## HISTORIC LANDMARKS COMMISSION

## **November 13, 2014**

Subject: REQUEST FOR CERTIFICATE OF APPROPRIATENESS HC-2014-33,

Subject: REQUEST FOR CERTIFICATE OF APPROPIATENESS HC-2014-37,

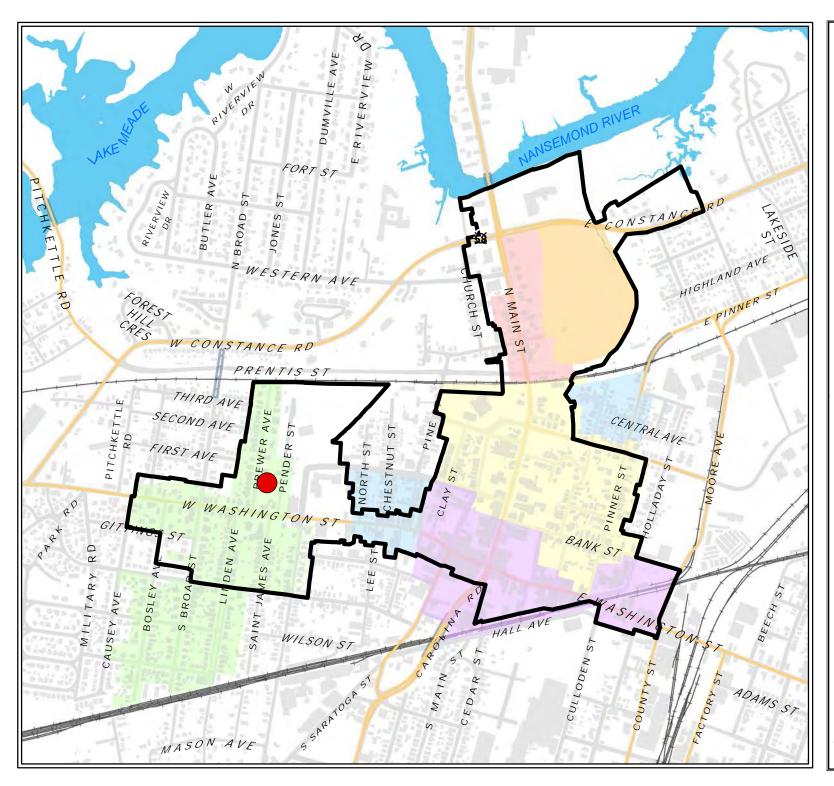
replacement. The style of the roof can be as important or even more significant in defining the character of the house. The existing Victorian shingle roof on the dwelling results in a simulated fishscale appearance on the roof. The installation of an exposed fastener metal panel system will be a significant departure from the appearance of the existing metal shingle. The selection of a replica metal Victorian shingle or an fishscale asphalt shingle on the main dwelling may be more appropriate in maintaining the character of the home.

The guidelines additionally do not provide guidance regarding color of the roof. Traditionally, metal roof tiles were unfinished at the time of installation and where painted in subsequent years in attempt to reduce wear and increase the longevity of the roof. The applicant has selected a light stone color, which will be unique to the district, in an attempt to reduce utility bills. However, the lighter reflective color of the roof does appear to fall within the Pratt and Lambert Williamsburg Color Collection pallet.

Given the age and condition of the existing roof its replacement appears appropriate. The installation of an exposed fastened metal panel system roof is in conformance with the guidelines which call for the original materials to be matched and a new roof will assist in maintaining the integrity of the historic structure. Additionally, the design of the neighborhood with urban scaled lots and the design of the house with a front facing gable serves to reduce the visibility of the roof.

- 1. The existing metal roof shall be replaced with an exposed fastened metal panel system roof in a light stone color.
- 2. The existing fascia shall not be wrapped and fascia trim shall not be installed along the eaves and rakes.
- 3. No further exterior improvements permitted without the issuance of a Certificate of Appropriateness.
- 4. All required permits shall be obtained from the Community Development Division.

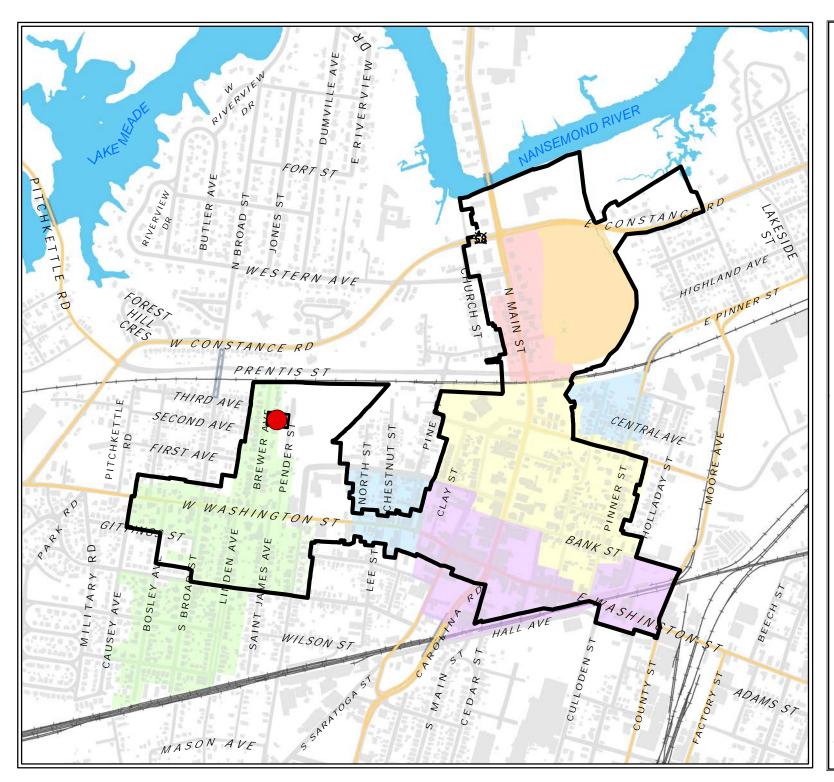
- 6. The applicant is proposing to utilize a carriage style door constructed of stamped steel (Amarr Classica carriage style door in the Northampton design). The Design Guidelines note that single garage doors should be eight (8) feet in width. As shown

on the drawing, the garage doors will be ten (10) feet in width and located on the North, West, and East elevations. According to the applicant, wider doors are needed for the applicant's large truck which will be parked in the garage.

As proposed the concrete driveway meets the Public Works standard maximum width of twenty (20) feet. The Design Guidelines call for driveways to have a traditional appearance, based on historic paving materials for residential settings such as river gravel, exposed aggregate concrete, colored concrete, brick, or concrete pavers. The majority of residences along Brewer Avenue utilize either full concrete driveways or concrete ribbons. Pender Street has no prevalent paving type due to the limited number of residences which utilize the street for property access; however due to its location to the rear of the dwelling, a concrete driveway appears acceptable.

- 1. Exterior will utilize Hardi-plank siding, prefinished in Evening Blue (equivalent to CW 617 Brafferton Blue).
- 2. The garage door will be the Amarr Classica door in the Northampton design in True White paint color. The 10' wide door will utilize the manufacturer's Thames window style with carriage style decorative handles and hinges.
- 3. The entry doors and trim will be painted white.
- 4. Roof will be architectural grade shingles (GAF Timberline Cool Series Antique Slate color).
- 5. Exterior entry doors will utilize panel design compatible with historical door styles found within the district. Glazing may be utilized and shall be compatible with historical door styles found in the district. Staff must review the proposed design and approve administratively prior to the issuance of a building permit.

HC37-14

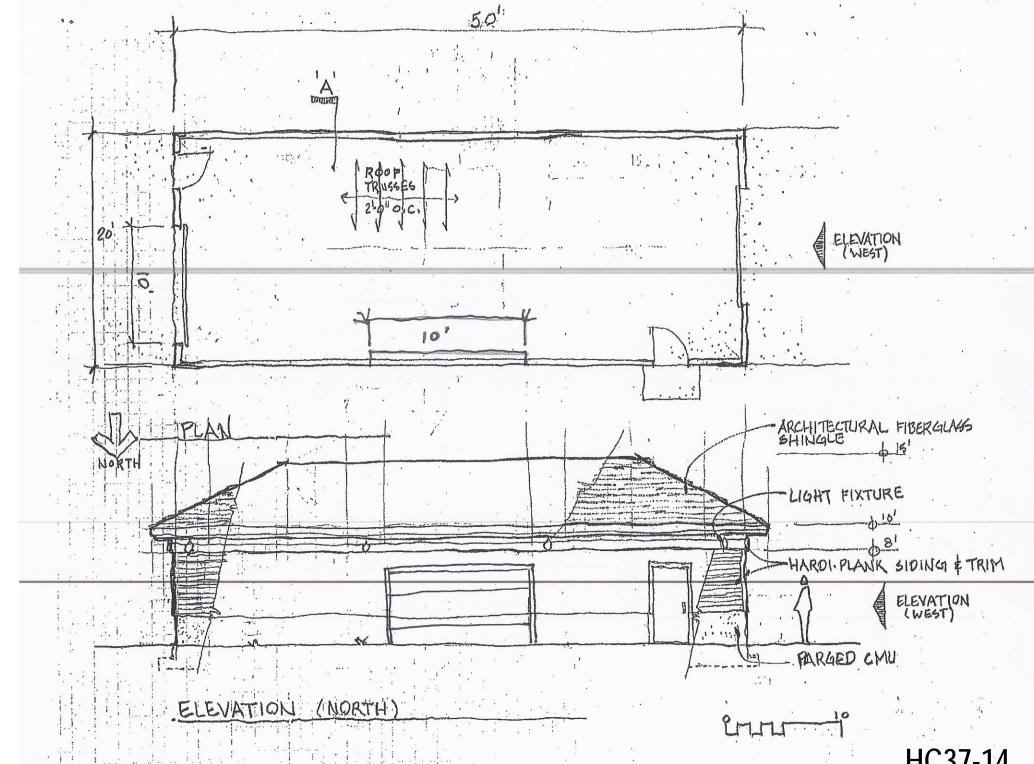
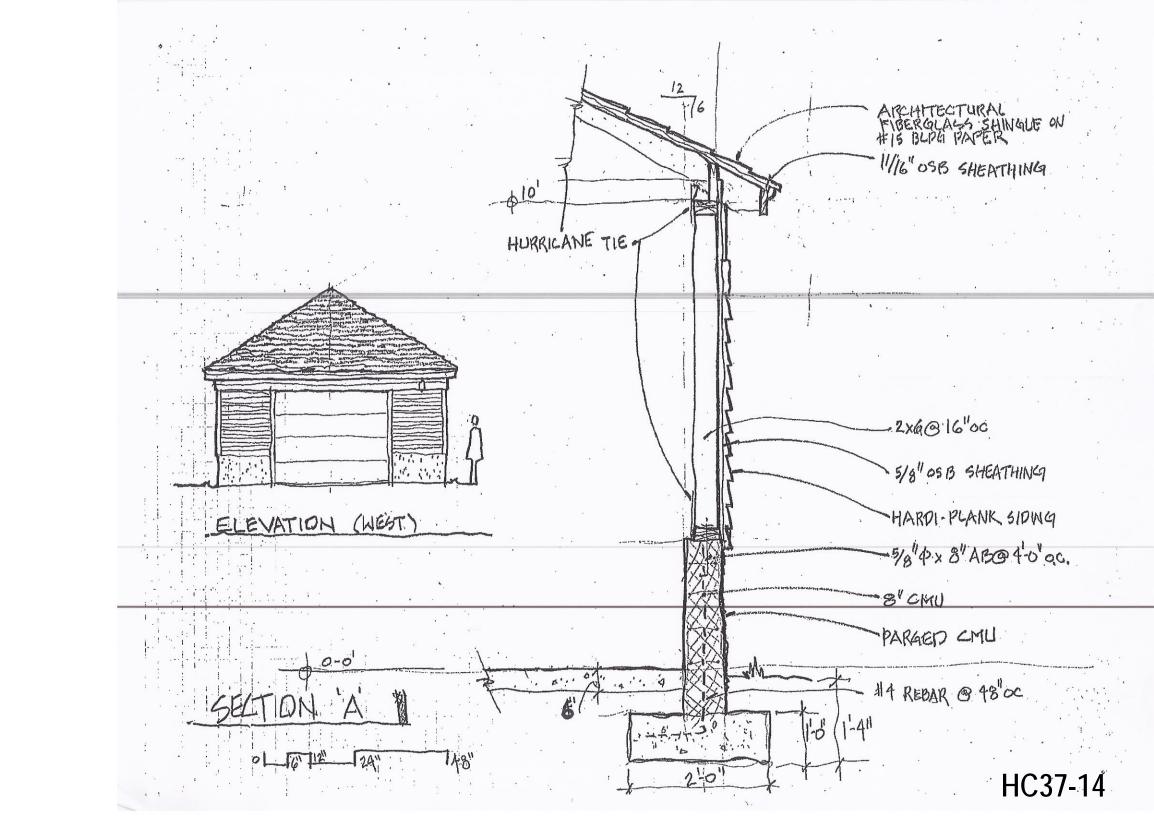
- 3. A 4-foot high parged masonry wall will be installed around the base of the garage.
- 4. Two (2) entry doors (steel cladded) are proposed but no drawing has been submitted which further identifies the style. The entry doors need to reflect the style and proportions of the doors used for the house which are primarily wooden paneled.
